UNITED STATES PATENT AND TRADEMARK OFFICE

Office Action Summary

10/782,752

SHIN, SANG HO

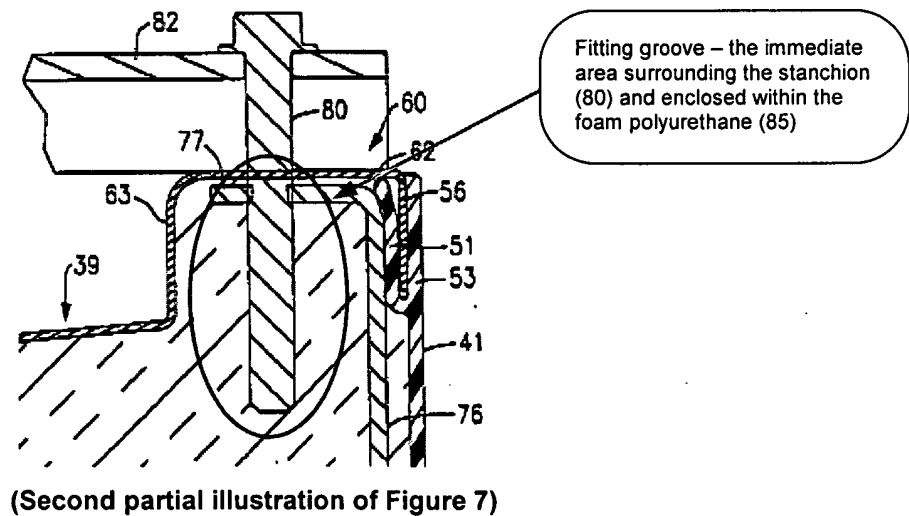
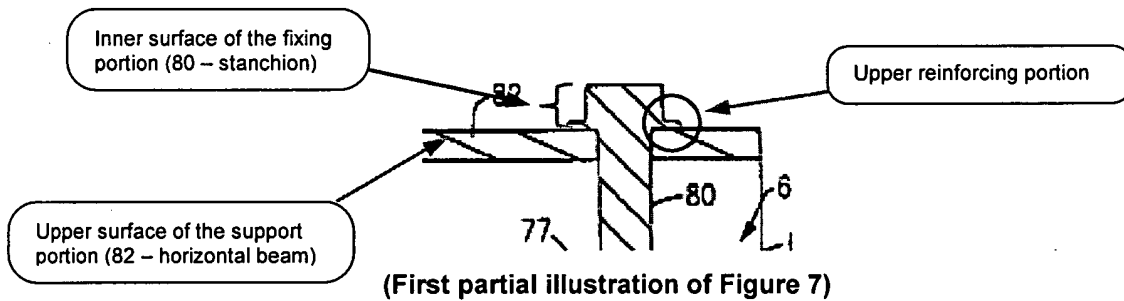
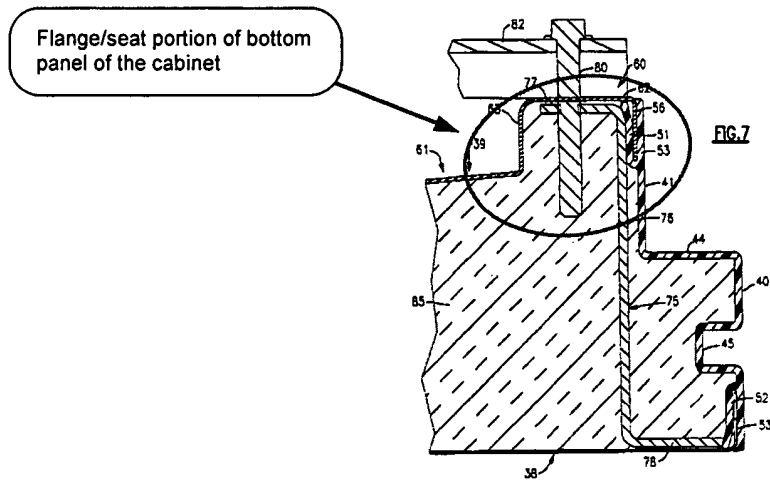
- the bottom panel of the cabinet includes a flange (as seen in the illustration of Figure 7 below) extending upward at an edge of the bottom panel (as seen in Figure 7; Figure 7 is an enlarged cross-sectional view of the floor panel [35] as

shown in Figure 2), and wherein the support member is attached to the flange (as seen in Figure 7).

- the support member includes a fixing portion (80 – stanchion) attached to the flange (as seen in Figure 7), a support portion (82 – horizontal beam) extending from the fixing portion to support the lower end of the heat exchanger (as seen in Figures 6, 7); and an upper reinforcing portion (as seen in the first partial illustration of Figure 7 below) connected between an upper surface of the support portion and an inner surface of the fixing portion (as seen in Figure 7);

- the support member further includes a lower reinforcing portion (75 – reinforcing member) connected between a lower surface of the support portion and an inner surface of the fixing portion (as seen in Figure 7) to prevent the support portion from sagging (as seen in Figure 6);

- the fixing portion includes a fitting groove (area in which the stanchion [80] is inserted into the floor panel [35]) into which the flange is inserted to hold the support member (as seen in the second partial illustration of Figure 7 below);
